**Lake Wilmore Maintenance Barn
City of Auburn, Alabama**

**Addendum 6
September 16, 2026**

LAKE WILMORE MAINTENANCE RFI's

SITE, PAVING, & UTILITY PLAN

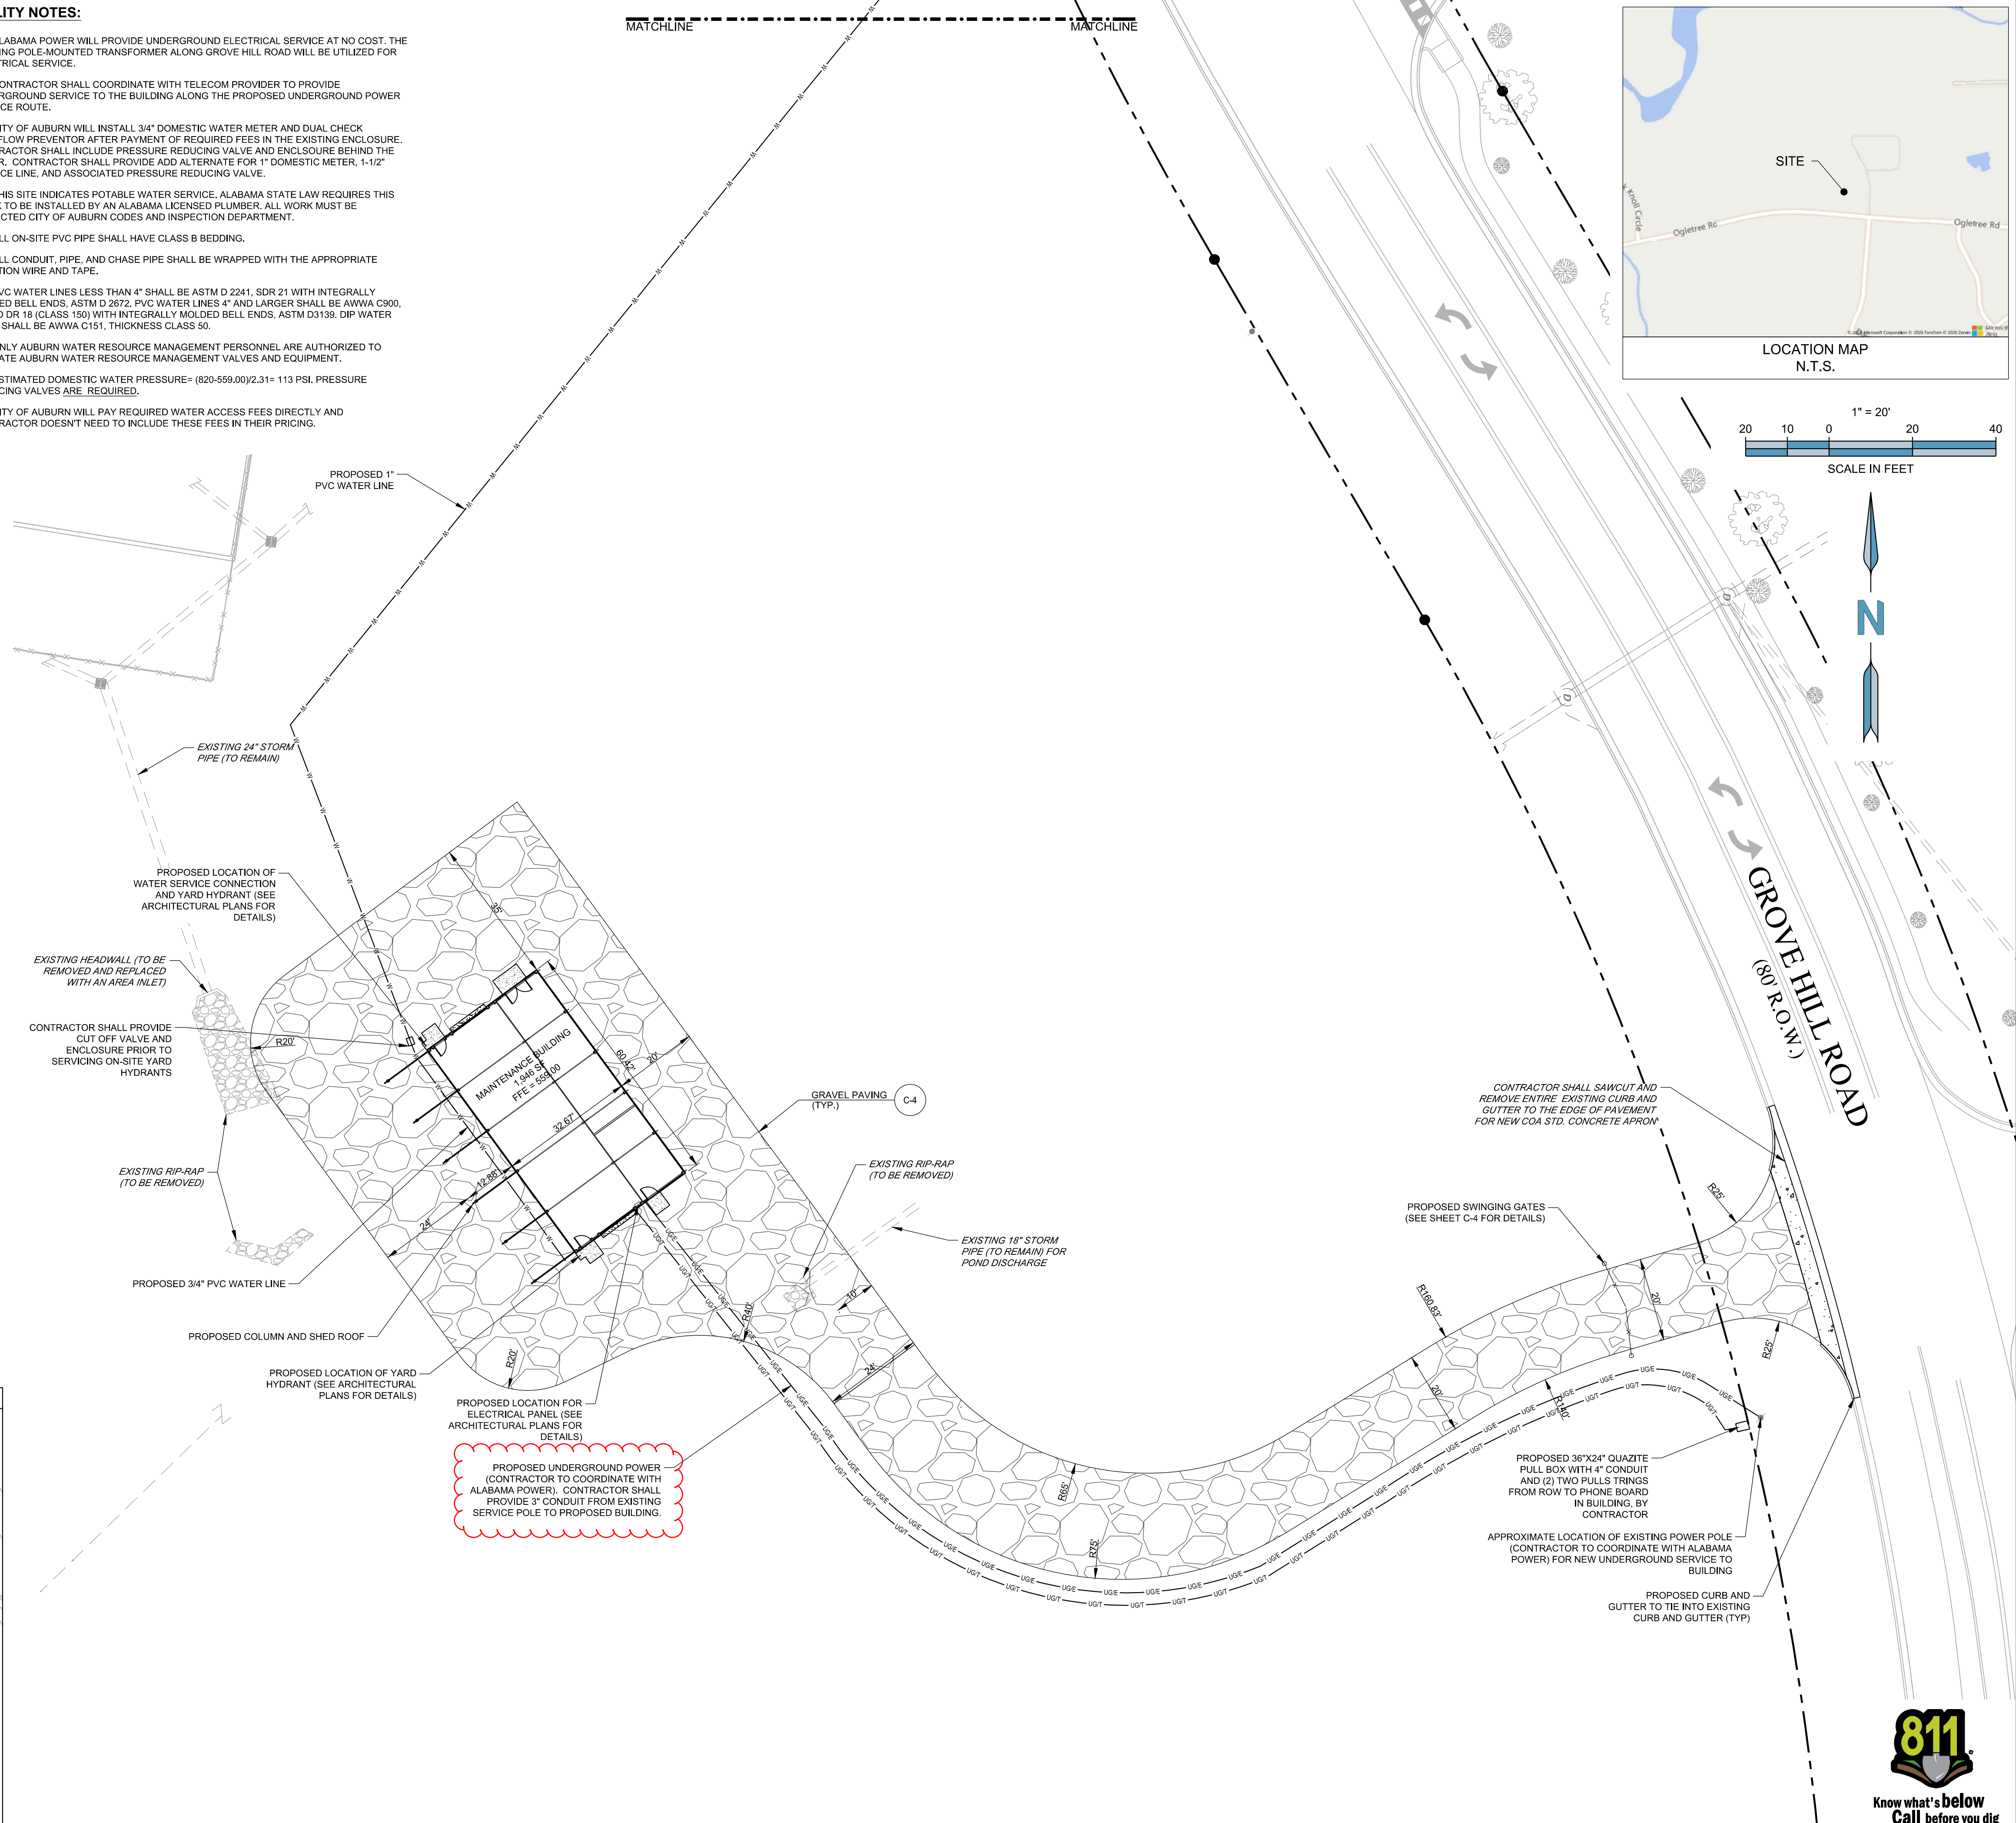
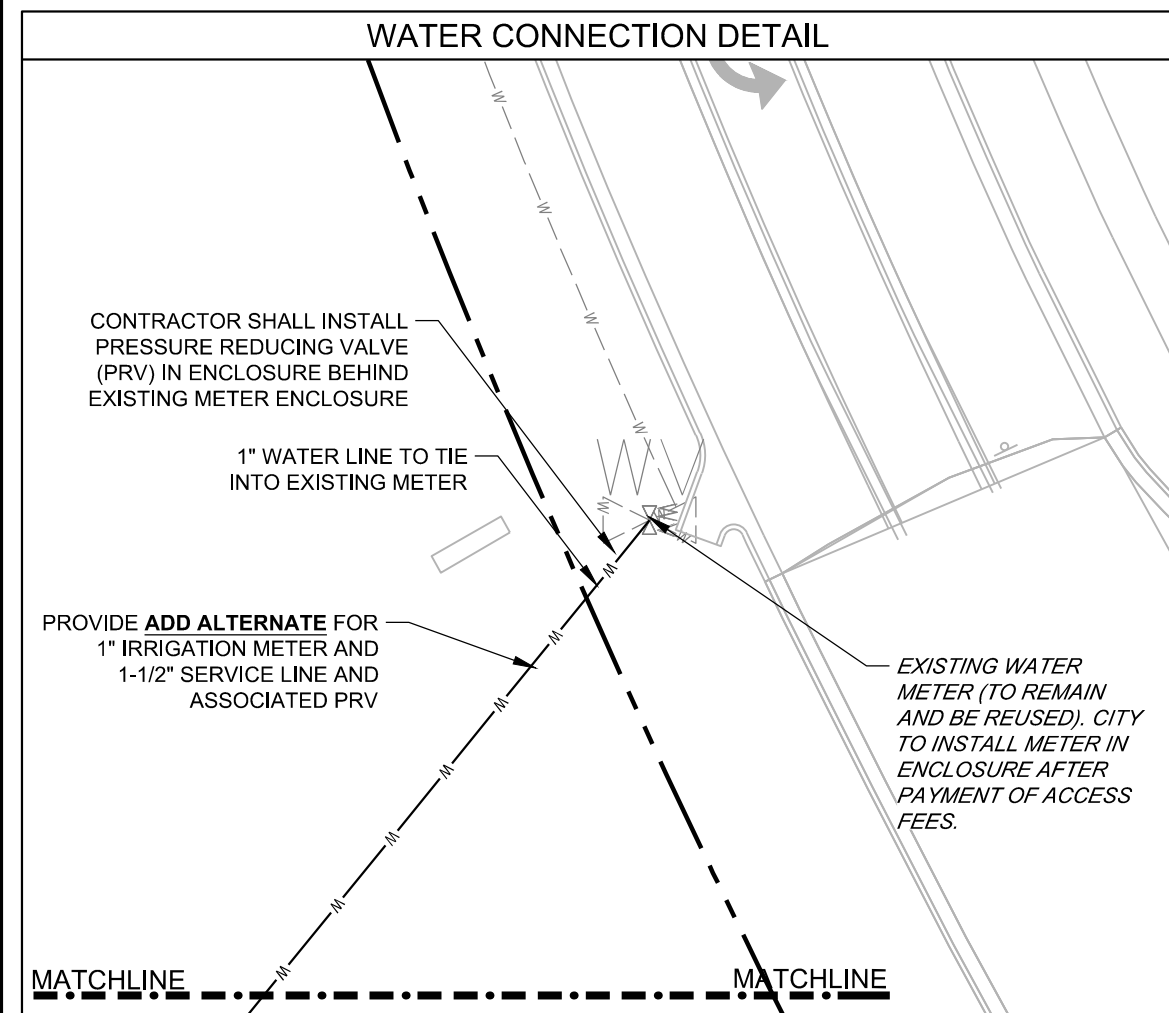
7	The way I interpret the drawings, Contractor to furnish and install UG/T but is not responsible for furnishing and installing any UG/E conduit. Can you confirm my interpretation is correct? If Alabama Power is providing material, would we still need to dig the trench?	SEE RFI #11 AL power is covering conduit and wiring for service to building. GC to cover conduit for telecom.

11	There is a detail for the contractor to furnish the 4" conduit from a Quazite box along Grove hill road to the new barn with pull strings. This makes us assume the contractor will only be responsible for installation of box and conduits and not assume responsibility for the utilities and coordination. Let us know if this assumption is correct. The alternative that includes surety cameras and key cards is also not assumed to change this. Contractor	CORRECTION TO RFI #7 There is a detail for the contractor to furnish the 4" conduit from a Quazite box along Grove hill road to the new barn with pull strings. This makes us assume the contractor will only be responsible for installation of box and conduits and not assume responsibility for the utilities and coordination. Let us know if this assumption is correct. The alternative that includes surety cameras and key cards is also not assumed to change this. Contractor would only be responsible for running data in the barn. ALPCO has confirmed that the contractor shall provide the conduit and coordinate with them. ALPCO will provide the wire.

would only be responsible for running data in the barn.	
12	See attached markup of floor schedule. It is our assumption that the enclosed athletic store room will be entirely enclosed in 1/2 moisture board (noted in green along with the shared wall of the other storage room. As for the other 3 walls of the storage room and the rest of the building, there will be no interior sheathing and will be bear studs. Let us know if our assumption is correct. All will be framed with horizontal 2x gurts in between 6x6 posts excluding partition wall between stage rooms.	I think my intent was that both storage rooms would have 1/2" green board in the whole room.
13	Sheet E500, Keynotes #4 and #5, specify add alternate #1 to provide 4" conduit and 2" conduit extended 150' to the telecom demarc location for telephone and CTAV services. However, sheet C-1 indicates a proposed in-ground box and conduit pathway extending to the building approximately 330'. Please clarify which conduit routing direction is to be utilized for pricing	GC to provide 3" conduit. See addendum 6 updated plan sheets.
